SERVICE BULLETIN

SB No. 89 Issue No. 1

TITLE ADDITIONAL AILERON TRIM TAB REQUIREMENT

T67B, T67C Series, T67M, T67M-MkII, T67M200, T67M260 and T67M260-T3A.

Fig 1
Plan View of Right Aileron

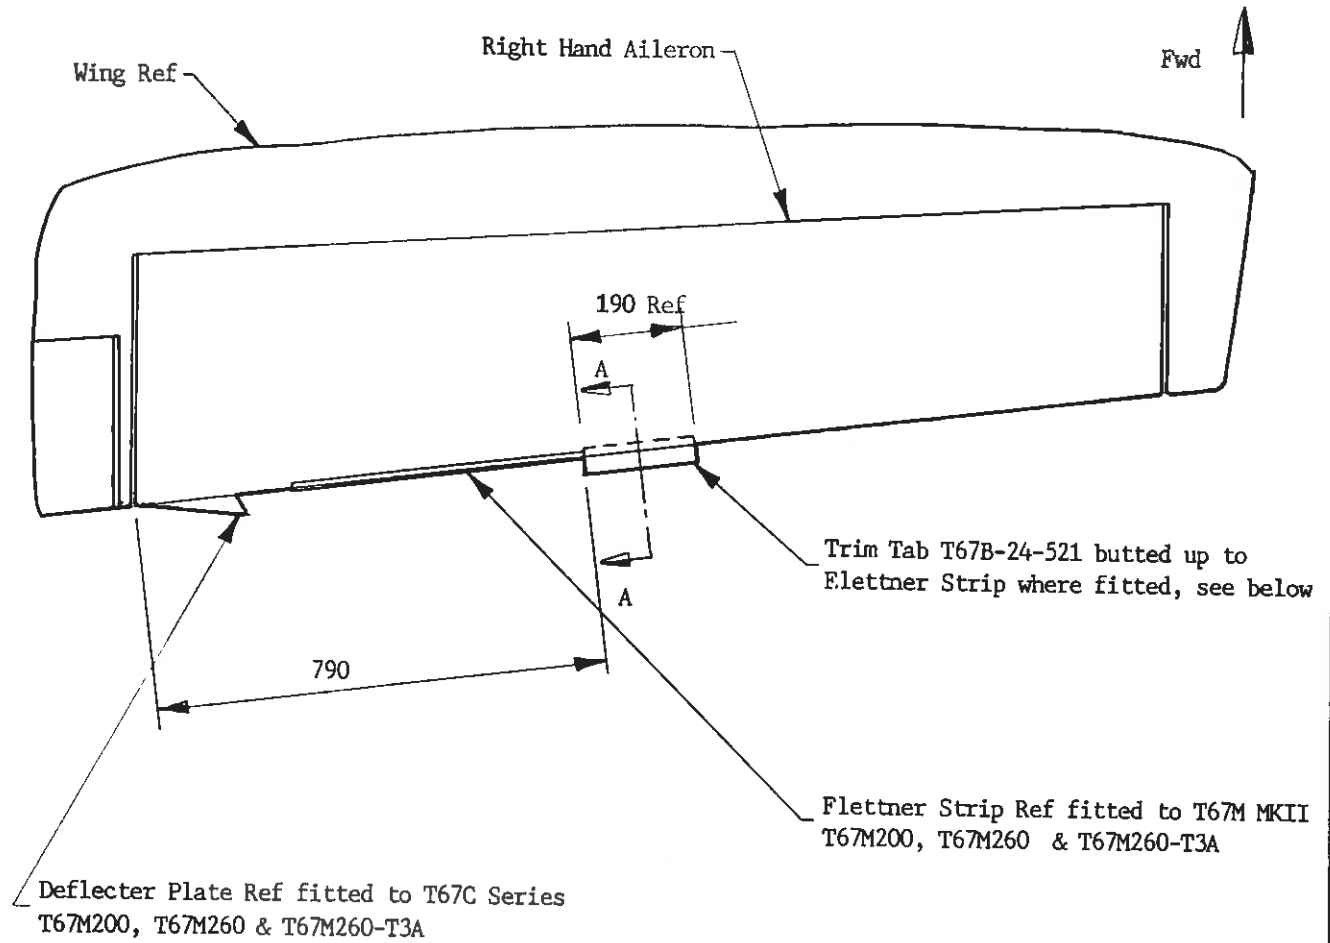
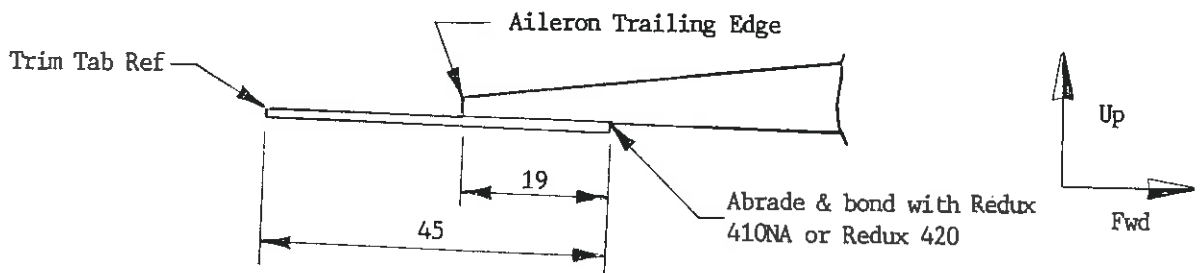
3. IF the aircraft does not meet the above requirements then an additional trim tab T67B-24-521 should be fitted to the starboard aileron as below.

- 3.1 Refer Fig 1. Mark out position of trim tab on right aileron.
- 3.2 Abrade areas to be bonded.
- 3.3 Bond trim tab to underside of aileron.

- 3.4 Referring to relevant Maintenance Manual, check aileron balance is within acceptable tolerance, if not re-balance in accordance with Maintenance Manual.
4. Adjust both tabs equally (one up, the other down) and re-fly the aircraft. Continue adjusting the tabs equally until the requirement of 1 above is met.
5. Annotate the aircraft logbook SB 89 completed and Mod M692 incorporated.
